Memorandum

RE: 271 Main St. East
Zoning Amendment
Submission No. 3

FILE: A4174A

TYPICAL ROAD SECTION

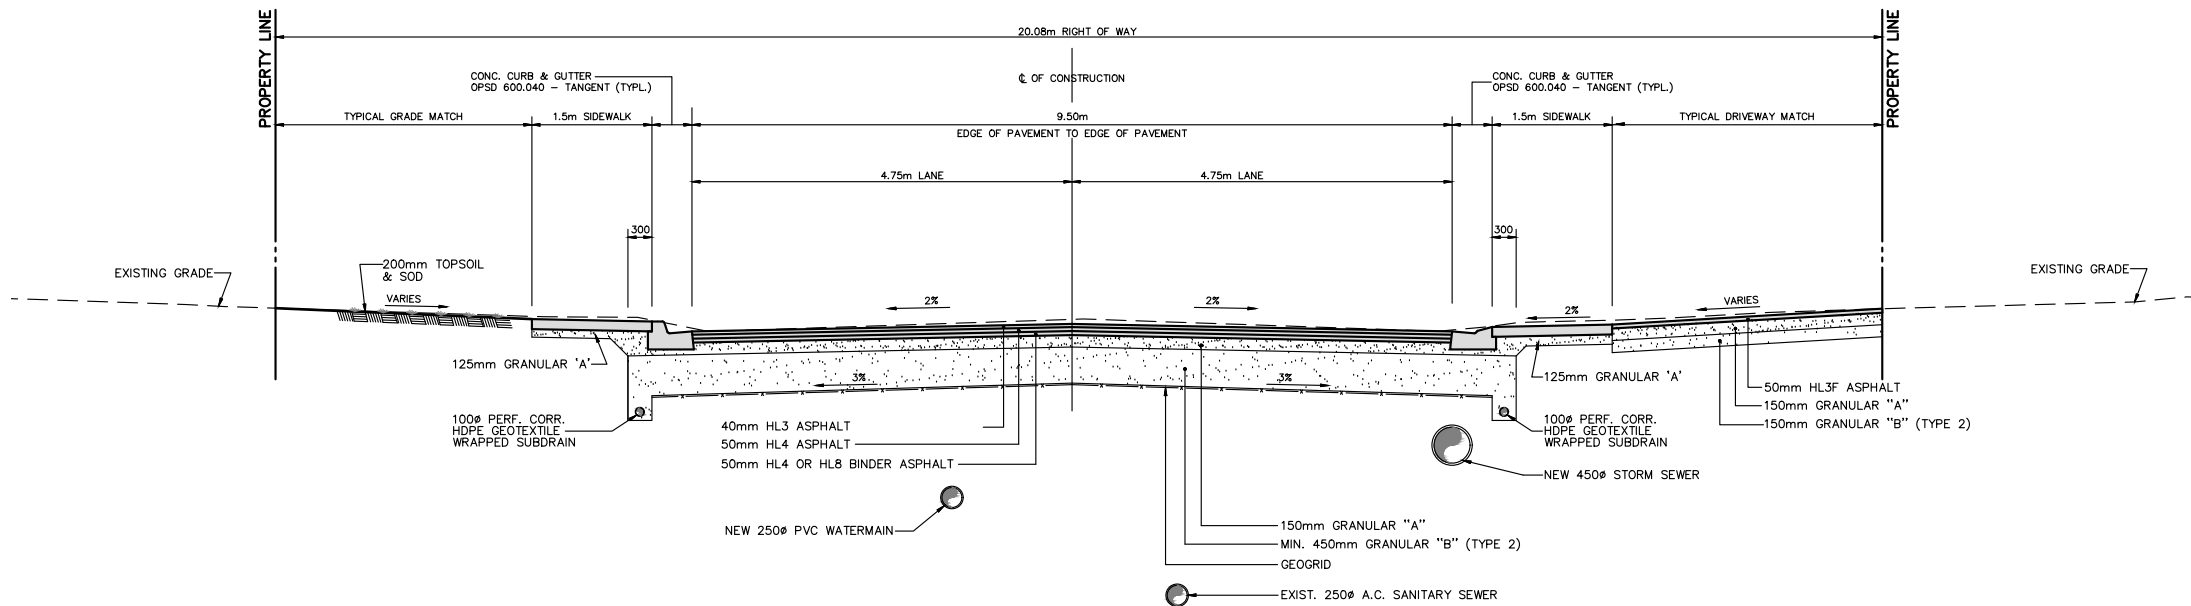
6. The construction limits for road excavation and restoration is to be clearly and specifically defined on the drawings. *Note: The existing road is to be restored as per the attached typical section.*
